APPLICATION TO THE PLANNING BOARD

Minor subdivision to subdivide the existing single-family residential lot into three (3) single-family residential lots, with the existing house on proposed lot 2.01 to remain). Various existing non-conformities exist with respect to the existing single-family home which is proposed to remain.

**Re: TagCap Atlantic 54 Rumson, LLC
Minor Subdivision Plan
54 Rumson Road (CR 520); Block 103 Lot 2, R-2 Zone
Completeness Review, Engineering Review and Fee Determination**

Application:	54 Rumson Road	Municipality:	Rumson
Applicant:	TAGCAP Atlantic 54 Rumson, LLC	Municipal Agency:	Planning Board
Owner:	Applicant	Block:	103
Design Professional:	InSite Engineering	Lot:	2
Plan Date:	8/22/2025	Date Received:	9/2/2025
Project Description:	3-lot residential subdivision		
Action Taken By:	☒ Development Review Committee Planning Director		
Approval Status:	Conditional Final Approval		
Action Date:	9/22/2025

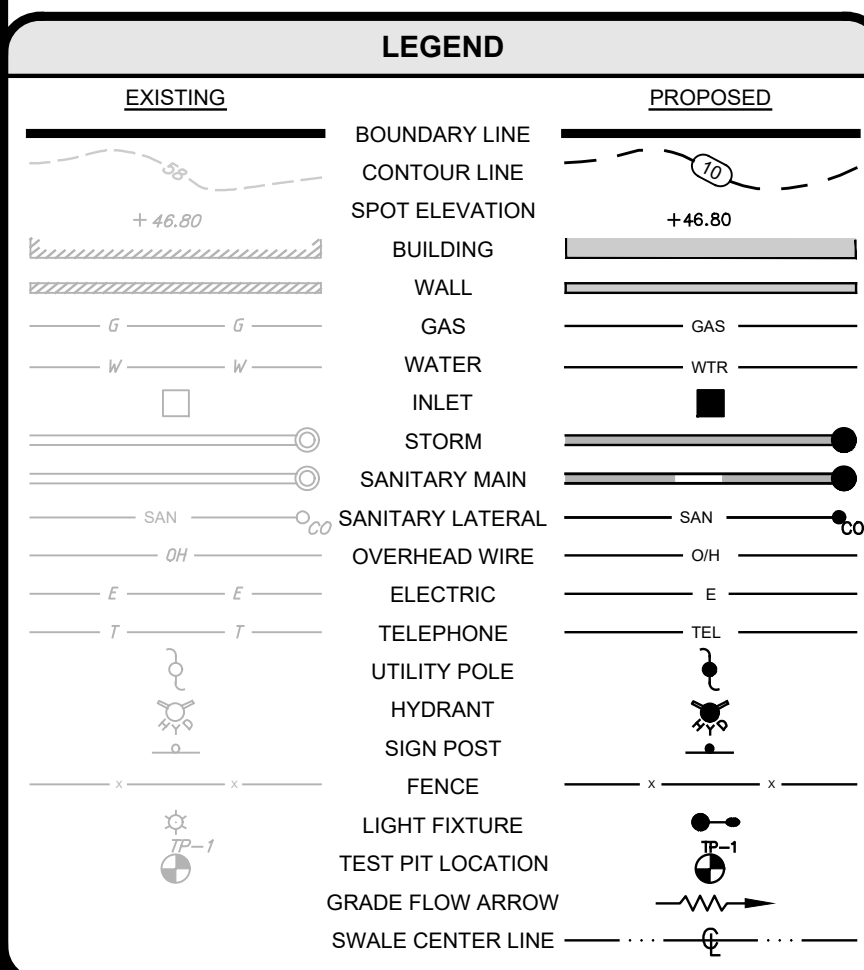
- 1.9 The plans should be revised to confirm that the width of each lot is measured at the minimum required front yard setback.

ALUMINUM FENCE
NTS

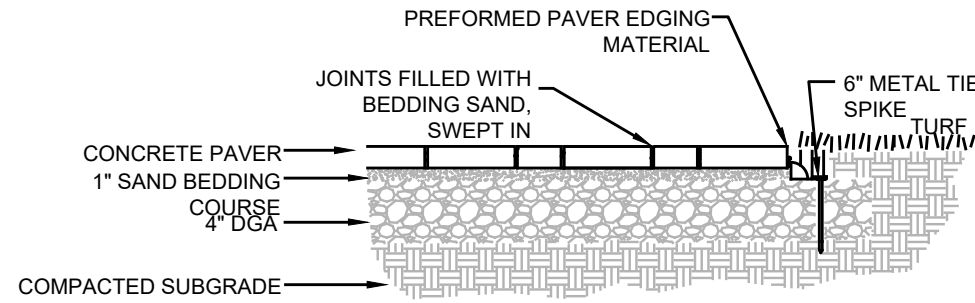
- 3.1 The plans shall be revised to clarify bedroom count of the proposed dwellings and if the parking requirement of Ordinance §22-9.2.b.1(b), Exhibit 9-1 will be met.
- 3.2 A detail has been provided for a 48" tall aluminum fence. Revise the plan to clarify where this is proposed.
- 3.3 The applicant should provide testimony on the available sight distance at each proposed driveway, including due to existing/proposed landscaping.
- 3.4 We defer to the Borough Fire Official for further review of the application with respect to emergency vehicle access and maneuvering.

STANDARD LATERAL CONNECTION WITH CLEANOUT - SEWER DEPTH 10' OR LESS
NTS

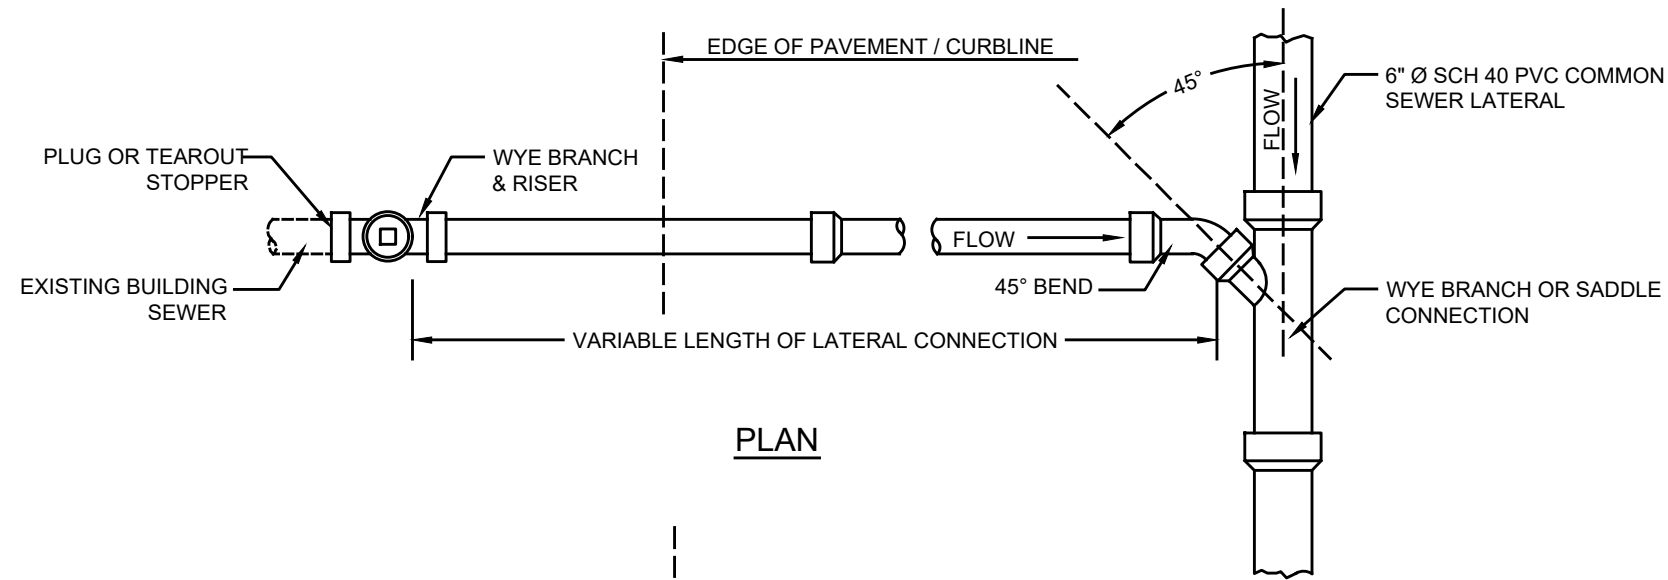
- 5.3 The lateral location and sanitary sewer lateral and cleanout details must be submitted for review and approval by the Superintendent of Sewers. Please note, a cleanout must be provided at the property line for both lots and the plans revised to include same.

To: Joe Barris, Director of Planning
9/22/25

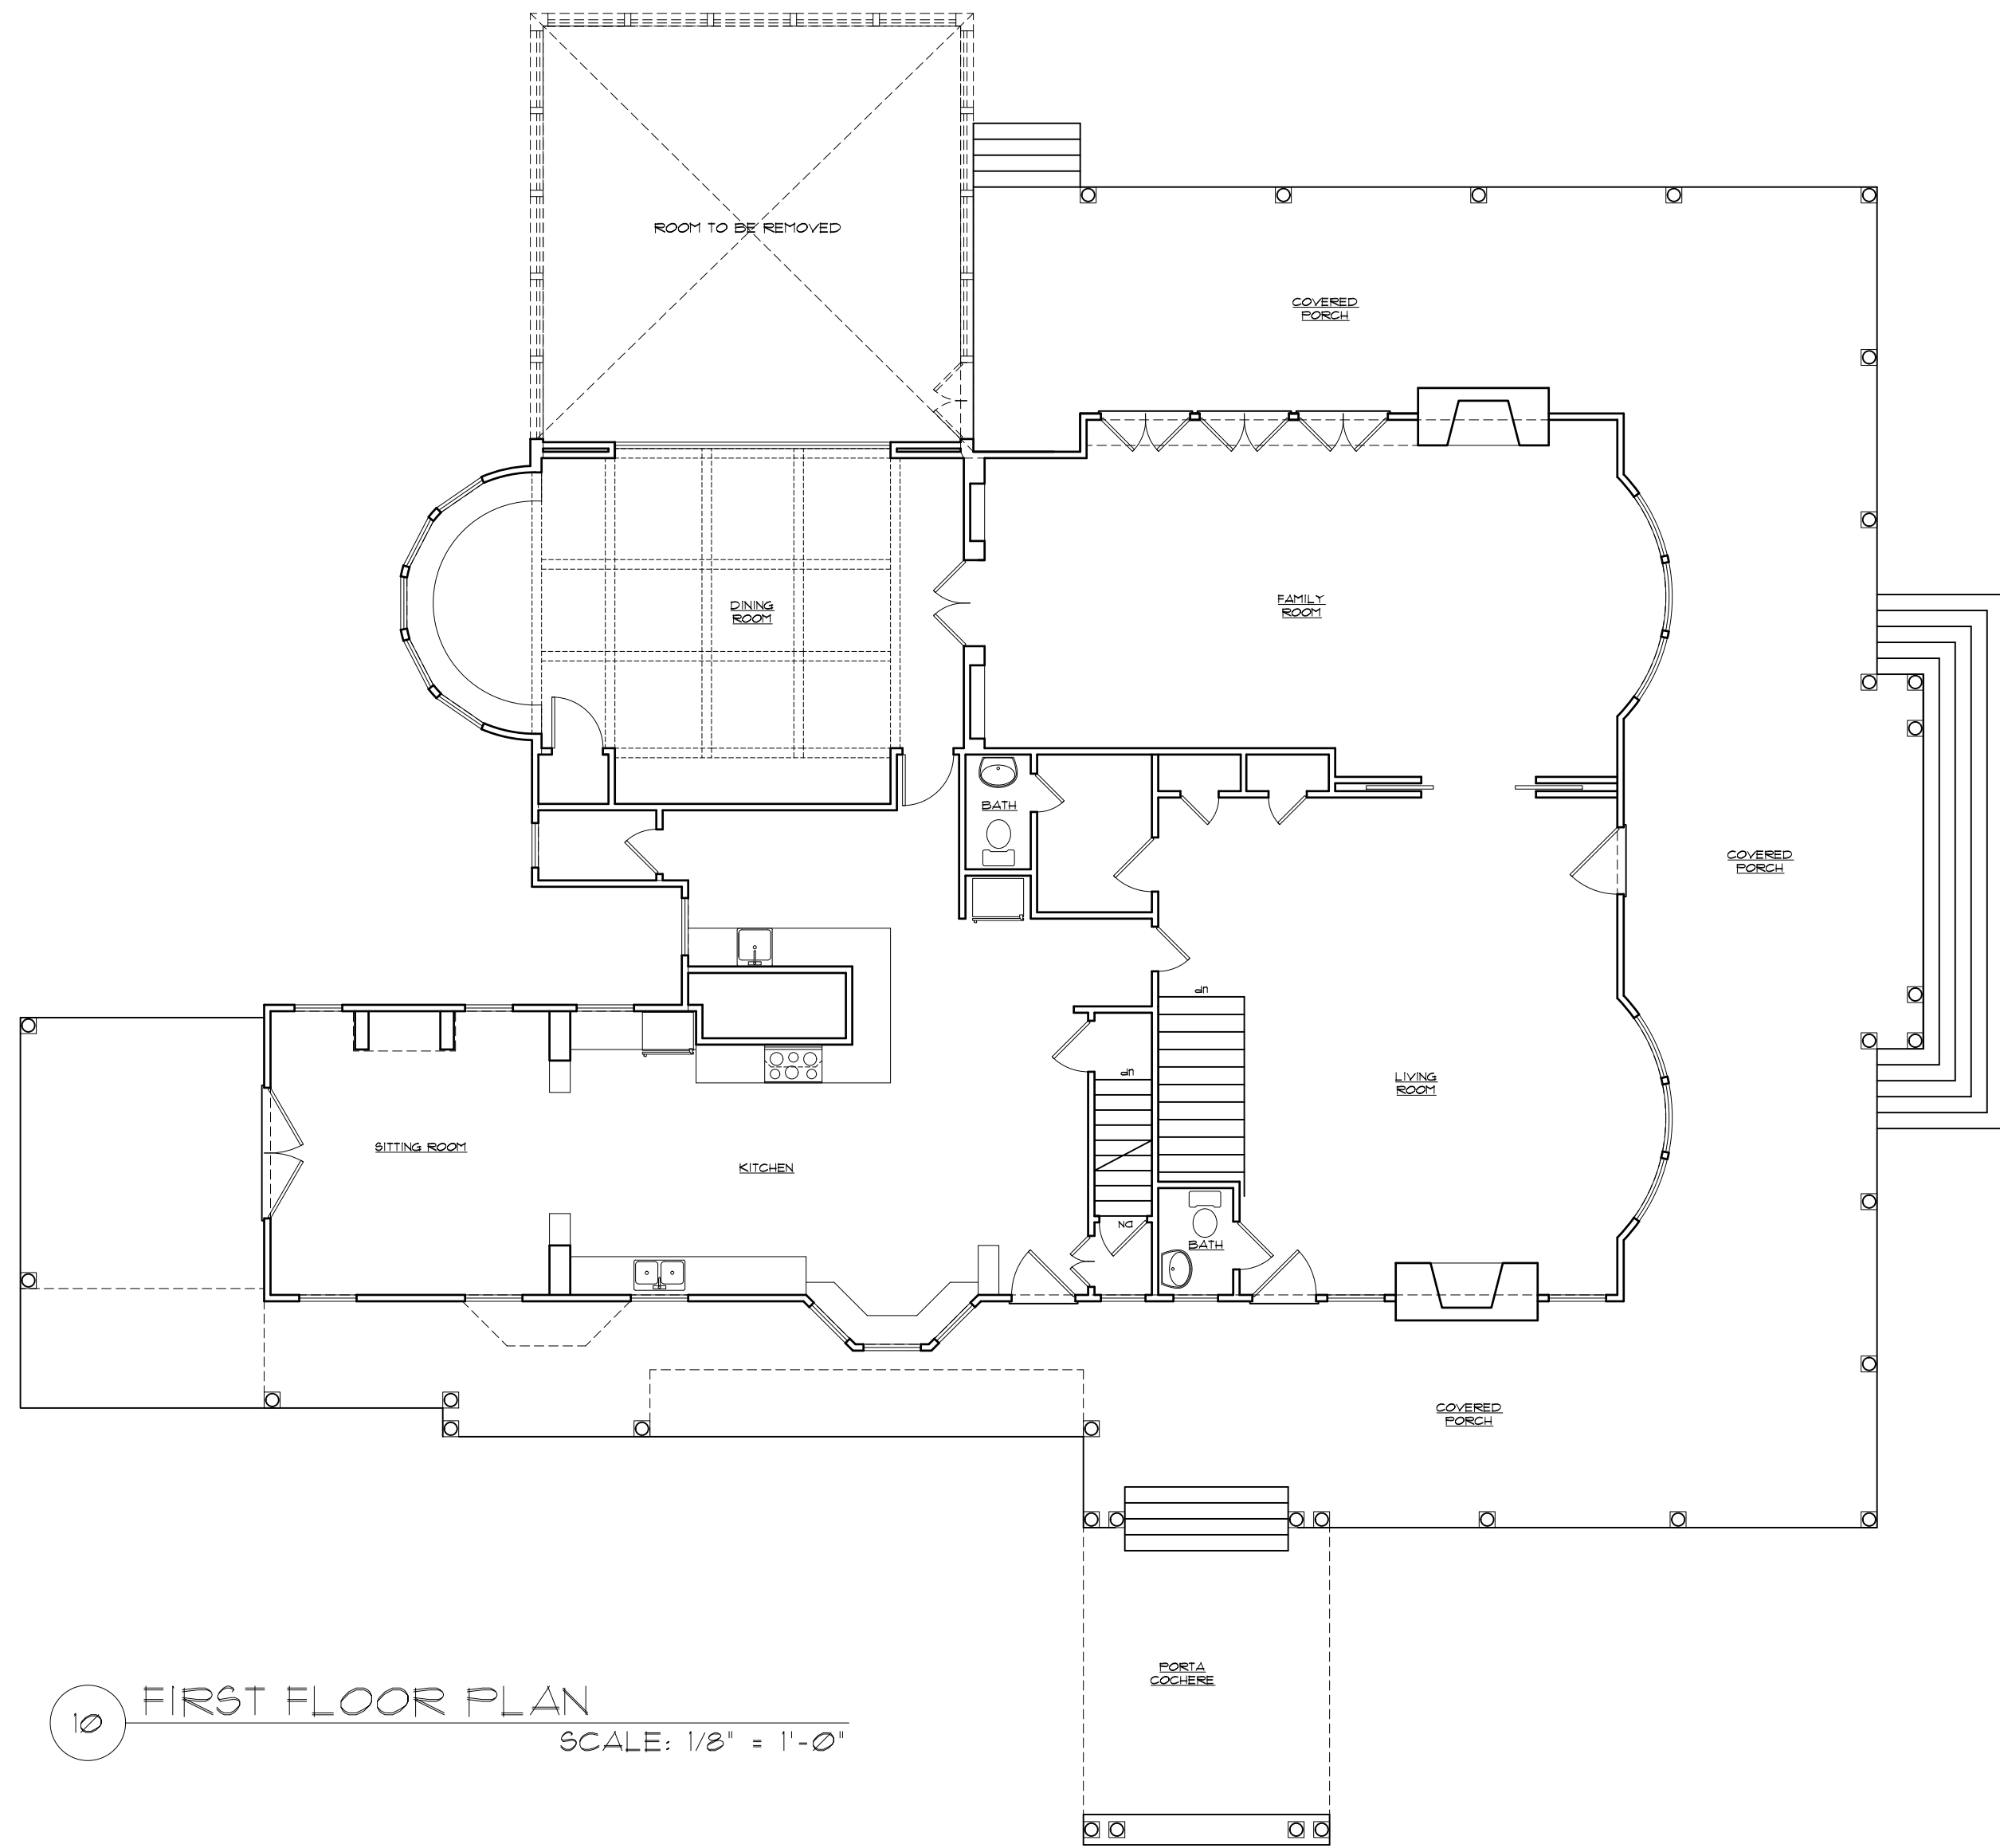
1. A 5-ft right-of-way dedication is proposed for the C.R. 520, Rumson Road frontage. The 5-ft dedication brings the right-of-way to the correct half-width at 30-ft. Submit a deed of dedication with parcel description for review by the county surveyor.

2. In addition to the right-of-way dedication noted above, a 25-ft radius corner arc dedication to Monmouth County should be indicated at the corner of C.R. 520 and Belknap Lane (Proposed Lot 2.01). Provide the following parcel data:

- a. Radius;
 - b. Arc length;
 - c. Central angle;
 - d. Chord bearing & length.
 - e. Incorporate into the deed of dedication noted in comment 1 above.
3. An existing brick wall indicated on the Existing Conditions & Tree Removal Plan, sheet C200 was not indicated on the Development Plan. Per sheet C200, the wall's location would fall within the boundary of the proposed dedication. Relocate the wall or provide an indemnification agreement to the County for potential damage to or damage caused by the location of the wall within the right-of-way.

4. Discharge into a County storm drainage system was not indicated on the plans. Minimal impact.
